Access Compliance Report

Public Rights-of-Way

(Curb Ramps)

Intersection ID: N/A	Main Street: YORK_CENTER	Cross Street: N/A	Location: NW
ADA ID: 9C0ECE65E4BE	Ramp Type: Perp	Initial Pass/Fail: Fail	Overall Compliance: No
			Severity Score: 33.75

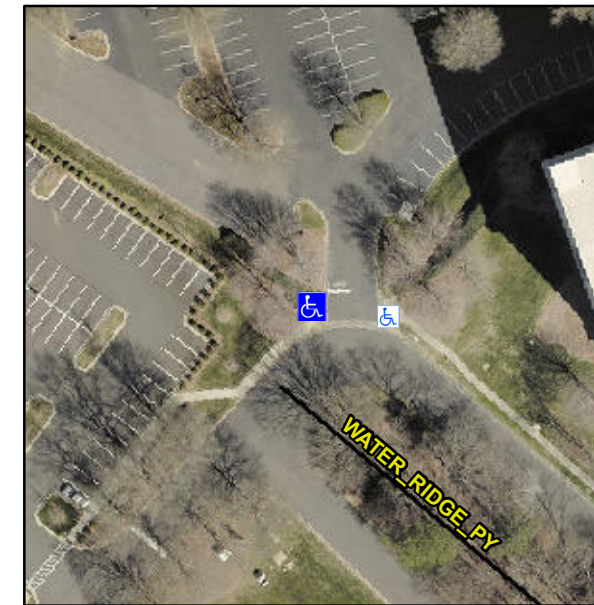
Not Found, R304.5.1, R304.5.3

Compliance	Description	Data	Compliance	Description	Data
N/A	Ramp Length (in)	60.0	Yes	Ramp Slope (%)	6.3
No	Ramp Width (in)	43.0	No	Ramp XSlope (%)	8.3
N/A	Flare Type LT	N/A	N/A	Flare Type RT	N/A
N/A	Flare Slope LT (%)	N/A	N/A	Flare Slope RT (%)	N/A
N/A	Flare Traversable LT?	N/A	N/A	Flare Traversable RT?	N/A
N/A	Landing Length (in)	N/A	N/A	DWS Provided?	N/A
N/A	Landing Width (in)	N/A	N/A	DWS Contrast?	N/A
N/A	Landing Slope (%)	N/A	N/A	DWS Length (in)	N/A
N/A	Landing X Slope (%)	N/A	N/A	DWS Full Width?	N/A
N/A	Landing Curb? (Y/N)	N/A	N/A	DWS Offset (in)	N/A
N/A	Shared Landing?	N/A			
N/A	Gutter Ponding?	N/A	N/A	Gutter Slope (%)	N/A
N/A	Gutter Lip Ht (in)	N/A	N/A	Gutter X Slope (%)	N/A
N/A	Painted X Walk1?	No	N/A	Painted X Walk2?	N/A
	X Walk 1 Direction	To E		X Walk 2 Direction	N/A
N/A	X Walk 1 Width (in)	N/A	N/A	X Walk 2 Width (in)	N/A
	X Walk 1 Slope (%)	1.8		X Walk 2 Slope (%)	N/A
	X Walk 1 X Slope (%)	10.5		X Walk 2 X Slope (%)	N/A

Remove & Replace Entire Ramp.
